Sherman Subdivision – Preliminary Plan Approval Extension
Staff Report for the October 26, 2022 Planning Board Meeting

Beauregard Subdivision – Preliminary Plan
Staff Report for the October 26, 2022 Planning Public Hearing

McManus Subdivision – Master Plan
Staff Report for the October 26, 2022 Planning Board Meeting

13 David Drive – Dimensional Variance
Staff Report for the October 26, 2022 Planning Board Meeting

Snippet of Sheet 5 Showing the Proposed Abandonment

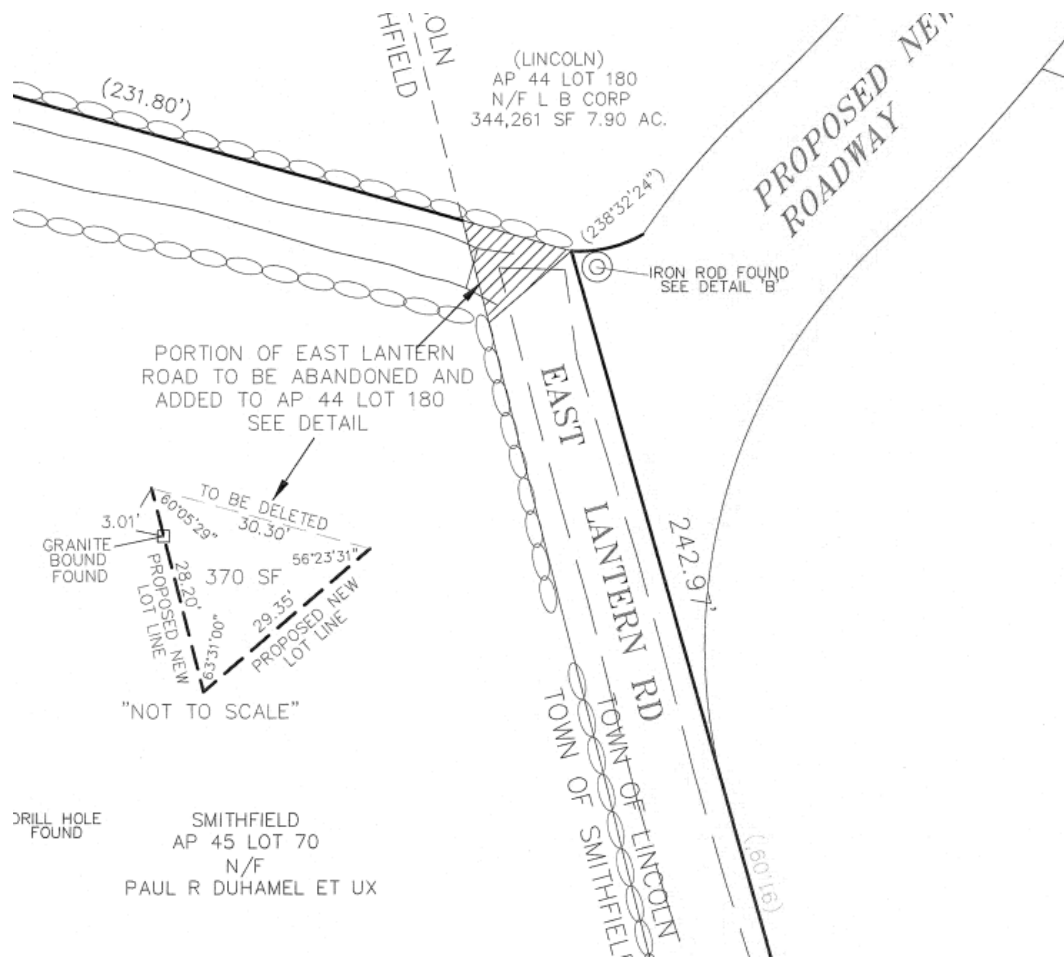
As discussed on page 4 regarding the discussion for the waiver of the centerline radius, in consultation with the Director of Public Works, the Town of Lincoln determined that connecting the roadways would have a negative impact on the residents of the Town of Lincoln. The proposal is for the Town to abandon a 370 ft² section of the existing right-of-way to be incorporated into future lot #6. This would effectively prevent the connection of the right-of-way. The applicant must apply to the Town Council for the abandonment separate from the subdivision review process. The TRC recommends that Preliminary Plan approval be conditioned to approval of the abandonment.

The subject site abuts the Town of Smithfield who were notified of the proposal. The Planning Department called Lincoln's Planning Department to discuss the abandonments, who questioned whether the future road connection should be blocked off and requested that if the abandonment does go through, that it include an easement for emergency vehicle access. This request was discussed by the TRC who felt the request was reasonable and incorporated the emergency vehicle access easement into the proposed conditions of approval.

7. The applicant shall coordinate the abandonment of a portion of the public right of way that will disconnect the public right of way in Lincoln from Clark Road in Smithfield to prevent a possible connection of the roads. An easement shall be provided to the Town of Lincoln and Town of Smithfield for emergency access.

Site Layout Plan (Sheet 2 of 3)

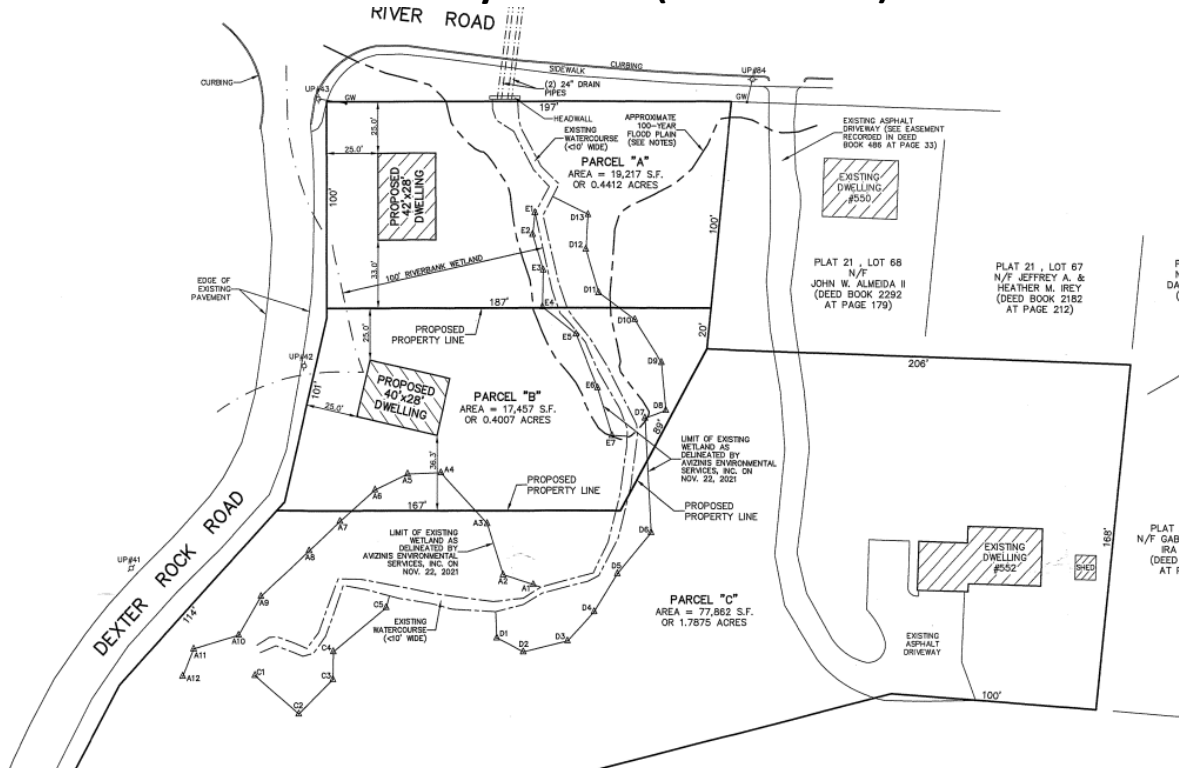
1. Provide water and sewer availability letters.
2. Add setback lines to the Site Plan (sheet 2 of 3) including for Parcel C.
3. Section 22.E.(3) of the Land Development and Subdivision Regulations states that lots shall not have interior angles greater than 200 degrees. The creation of Parcel B creates an interior angle greater than 200 degrees on Parcel C. Is a waiver requested?

Architectural Site Plan

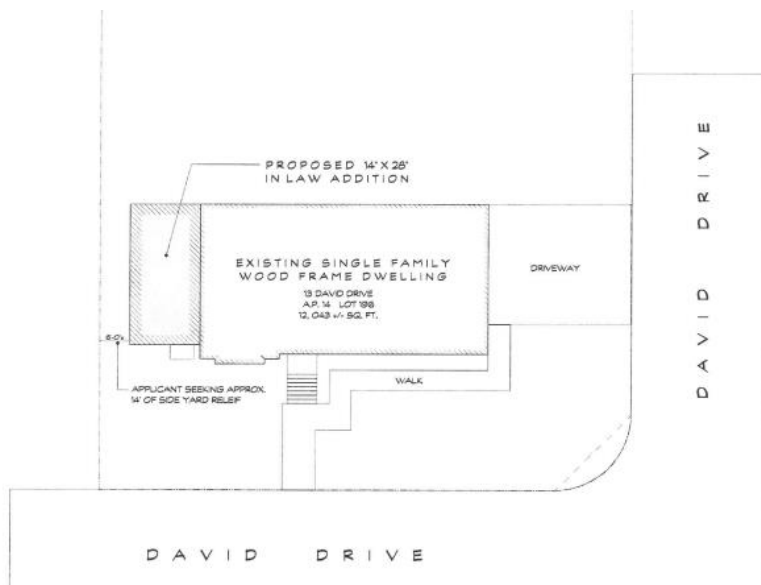
The TRC identified issues with the plans for the proposed addition. The survey plan has hand-drawn dimensions that may or may not be from the surveyor, and architectural site plans cannot be used to accurately identify the exact location of the lot lines in relation to the addition. The survey shows the existing home to be 19.7' away from the side lot line and the addition is 14' wide, resulting in a distance of 5.7' between the proposed addition and the side lot line, whereas the architectural site plan shows a dimension of 6'.

Despite the insufficient/inconsistent materials, the TRC did not feel that developing within 5.7' of a side property line is appropriate at this location, especially not at two-stories high. Lesser encroachments could be appropriate, but this proposed encroachment is not consistent with the neighborhood. Furthermore, there is sufficient buildable area for an addition in the rear of the residence next to the garage, and therefore the TRC felt that this was not the least relief necessary.

The TRC reviewed the application for the dimensional variance and due to the findings that the encroachment is too significant and may not be the least relief necessary, the TRC recommends that the Planning Board make a **negative recommendation** on this application to the Zoning Board of Review.
